RE: **Palen Solar Power Project, Docket No. 09-AFC-7**
Responses to January 14, 2010 CEC Workshop Queries
Technical Areas:
Soil & Water Resources (supplemental data for DR-S&W-242)

Palen Solar Power Project

Soil and Water Data Responses to January 14, 2010 CEC Workshop Queries

DR#242 Supplemental---Soil and Water:

DWG: H:\60202528 Solar Millennium\Palen\CADD\Civil\Sheet\conceptual civil plans\C-018 PALENC-PD-103.dwg Layout Name: PD-103 - Plotted by: Gonzales, Tom Date: 1/26/2010 - 1:10 PM
XREFS: xcrp - g-bd_2000 (Drainage) IMAGES: palen-01 - Palen\Layouts\section_3.jpg

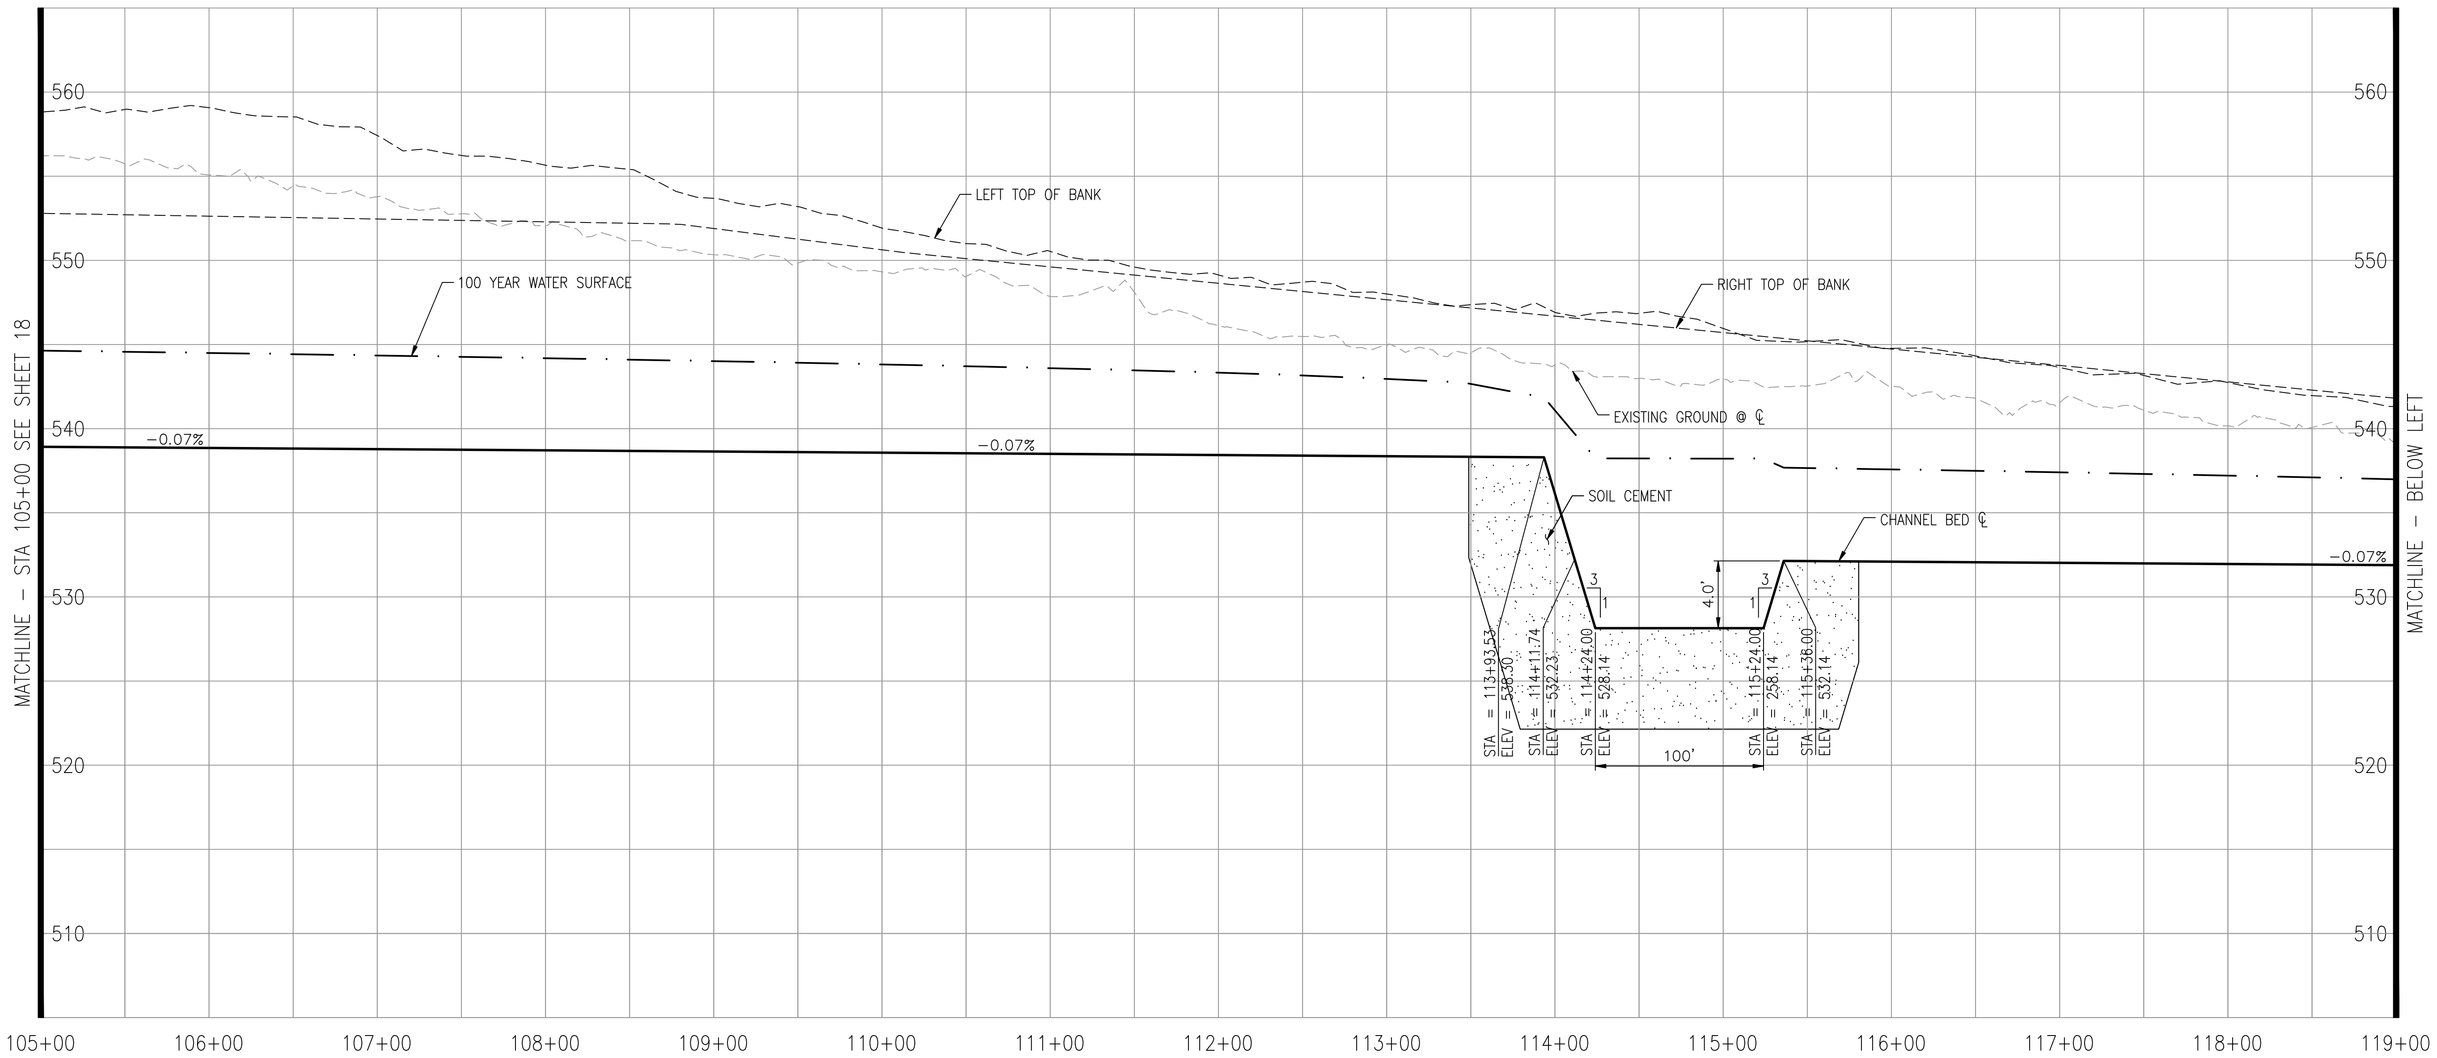
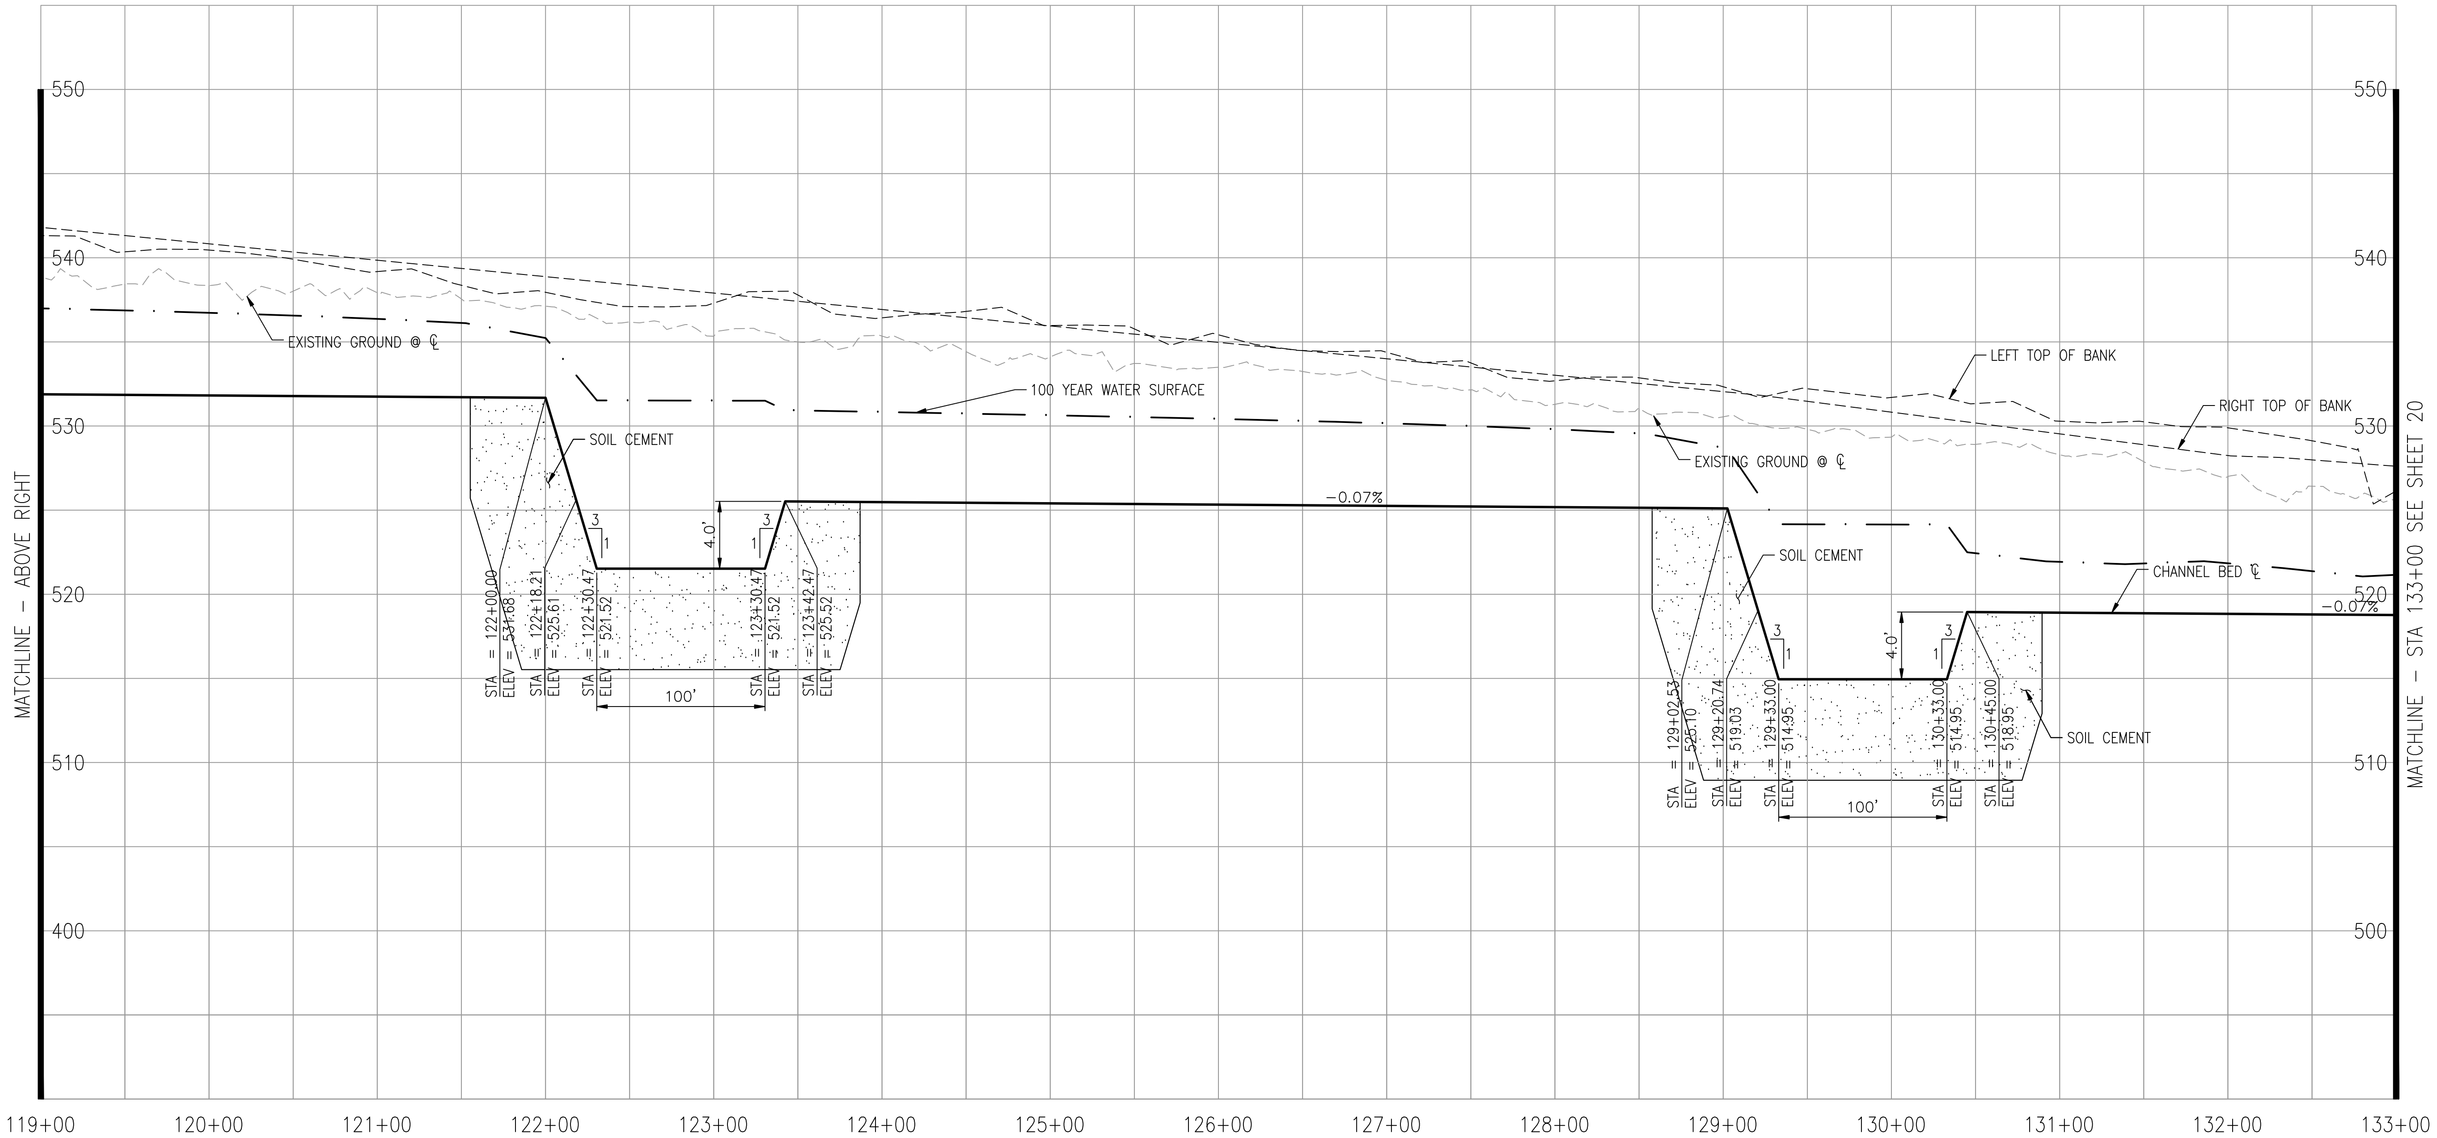
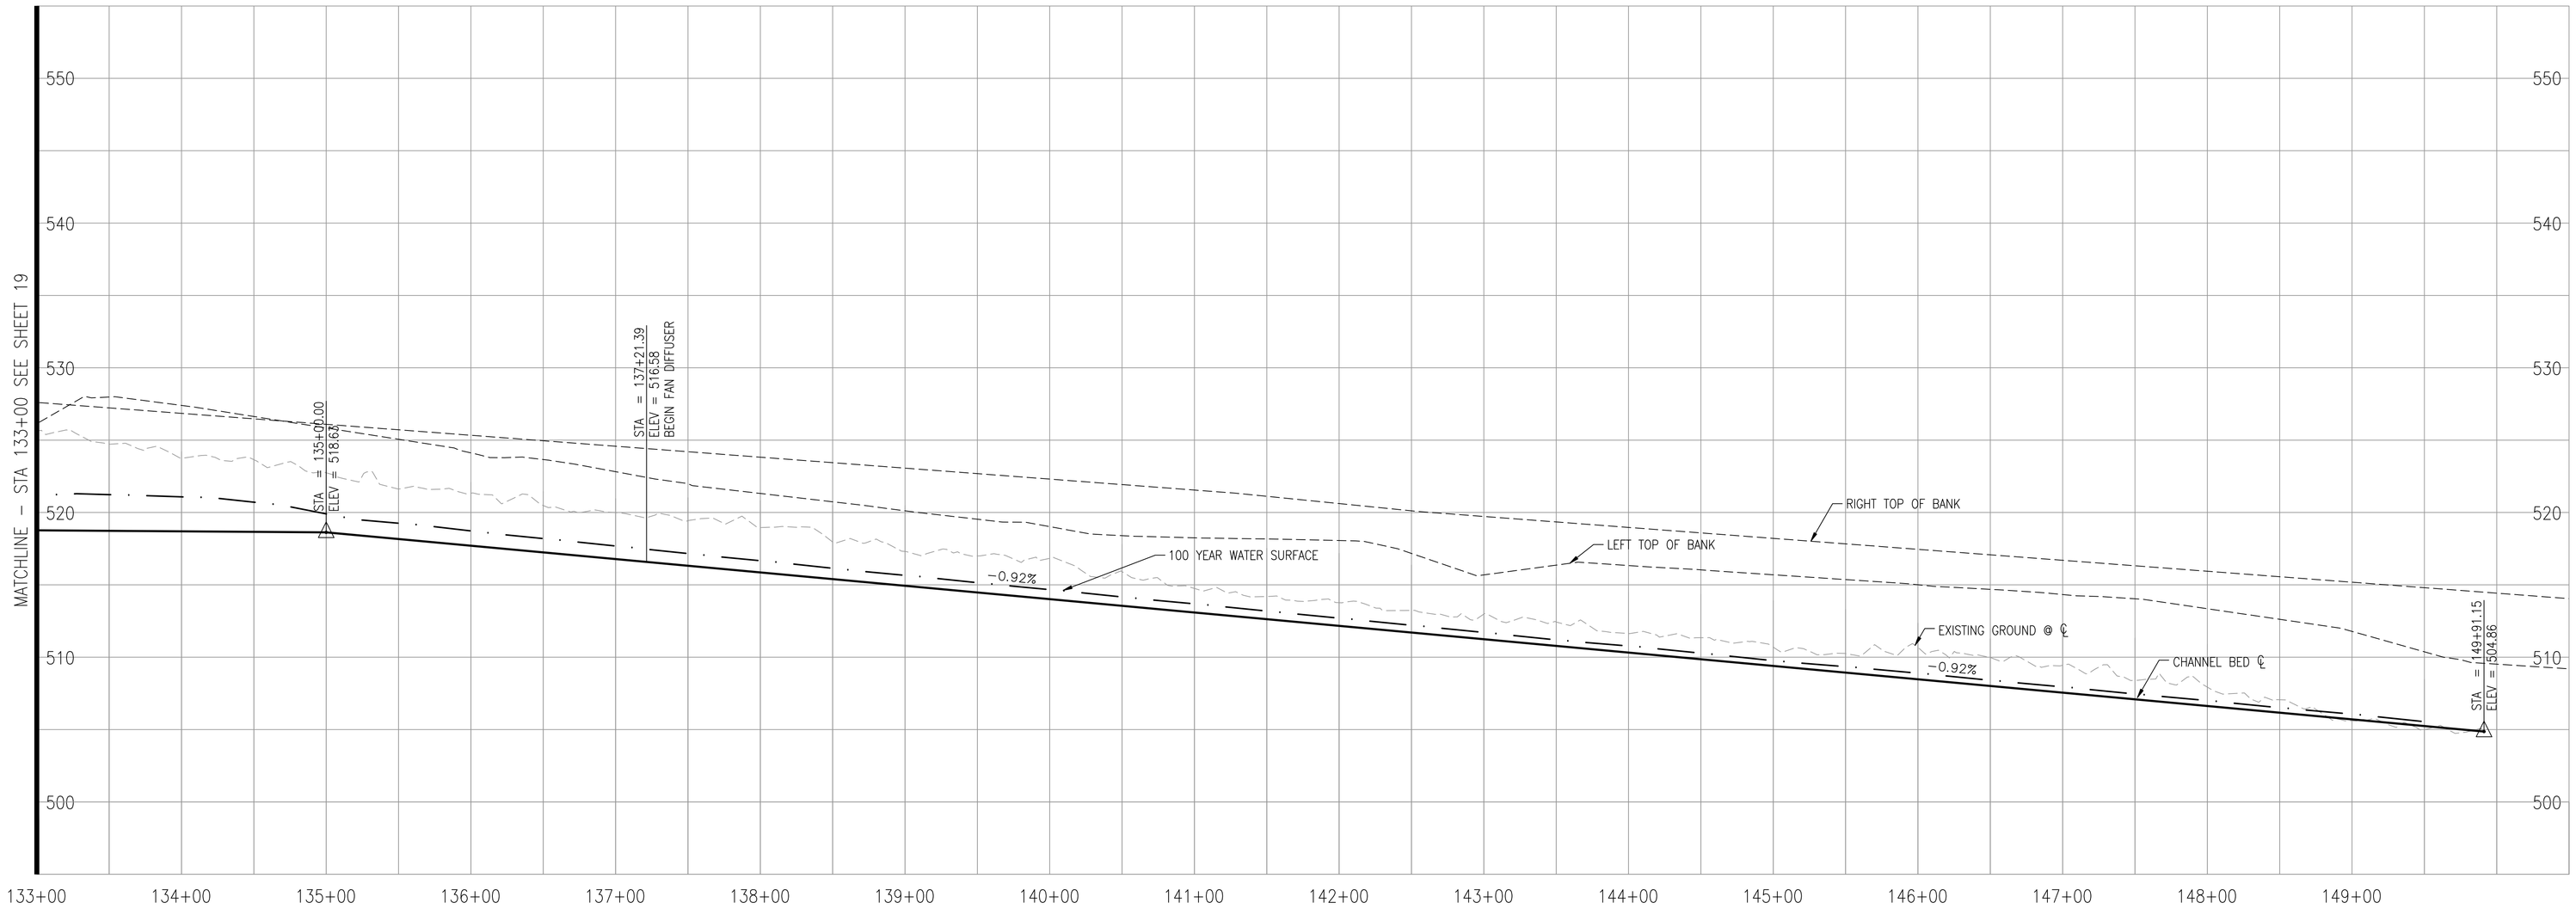
Add 100-yr. water surface elevations on profiles for main channels (both collectors and conveyance).

The 100-year water surface profile has been added to the plans and is provided as part of this response.
